DAUPHIN COUNTY SUBDIVISION/LAND DEVELOPMENT REVIEW REPORT

Plat Title: Lexeen Incorporated

Project Description: Proposed subdivision to correct boundary lines.

PRELIMINARY/FINAL SUBDIVISION PLAN
FOR

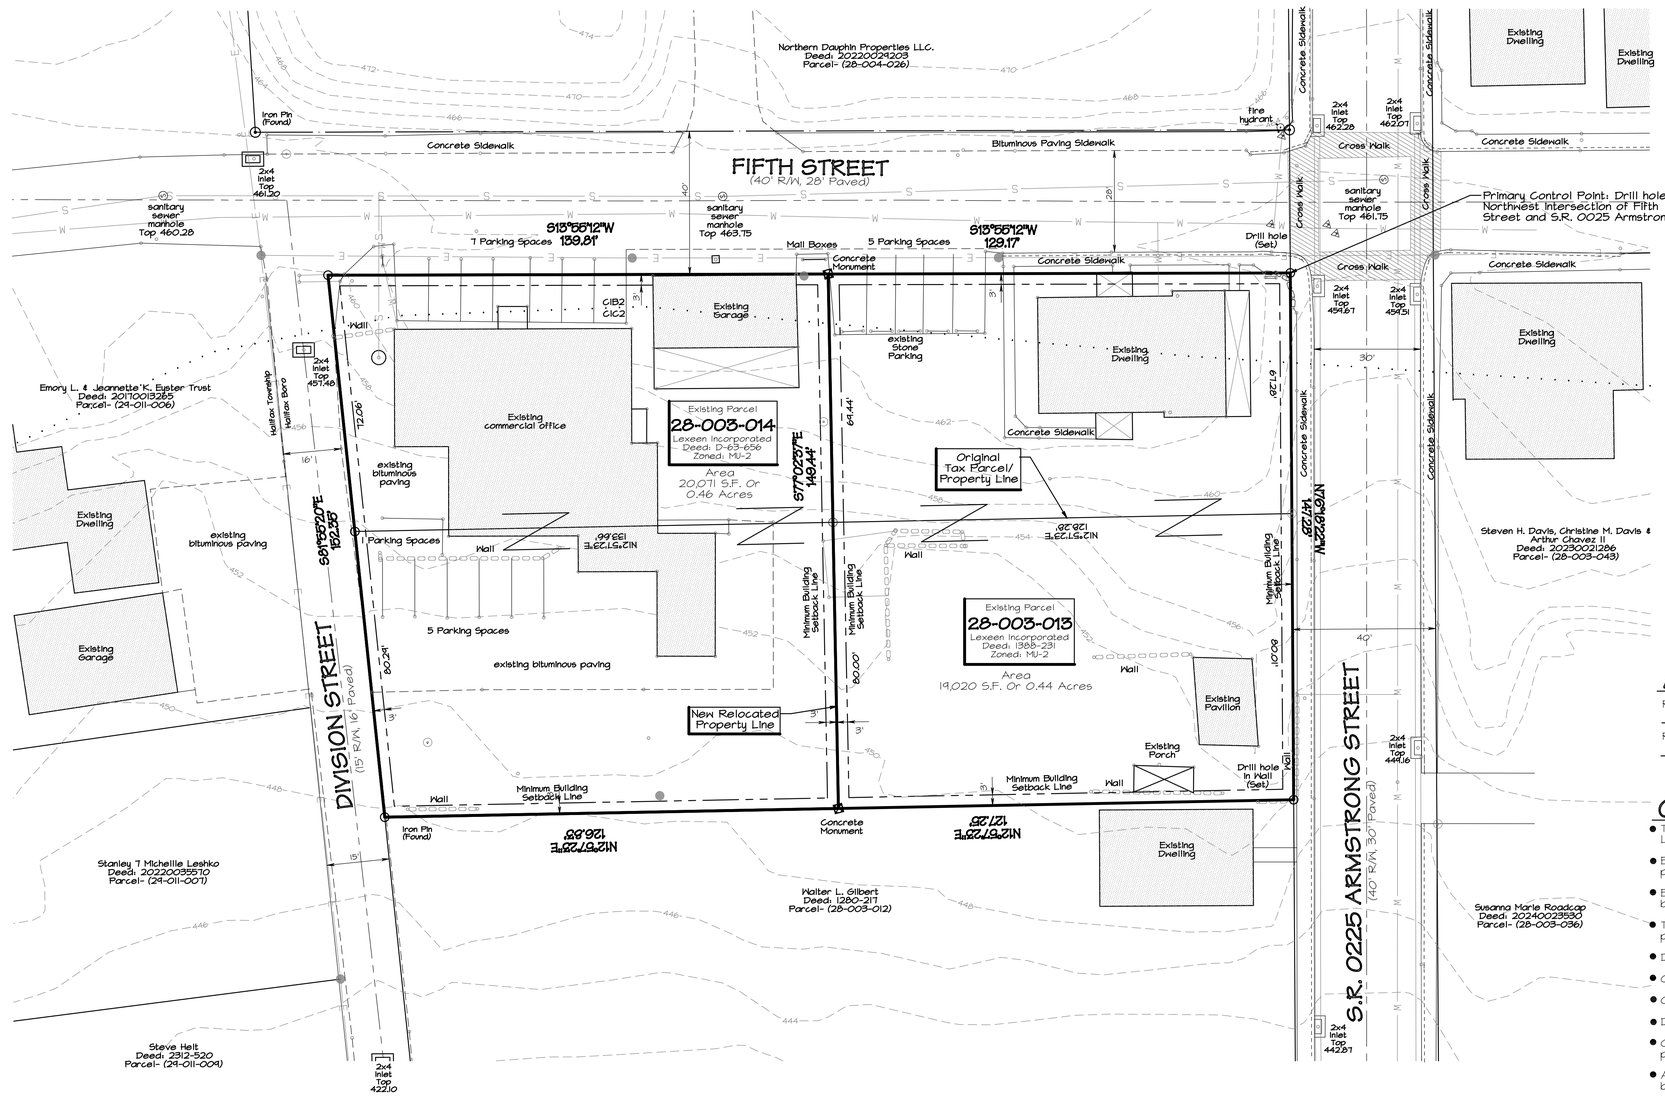
1. The plan shall be drawn at a scale of 1"=100'. (S-LD § 502.1) The application shows the applicant's intent to request a modification of this requirement. If a waiver is being requested for plan scale as shown on the County application, it should also be shown on the plan.

2. Notes should be placed on the plan stating each waiver/variance that is requested with areas for the approval date of each waiver/variance if granted. The reviewer notes that a note already exists on the plan for a waiver of preliminary plans but does not include an area for an approval date.

3. Monuments and markers shall be set in accordance with S-LD § 701.
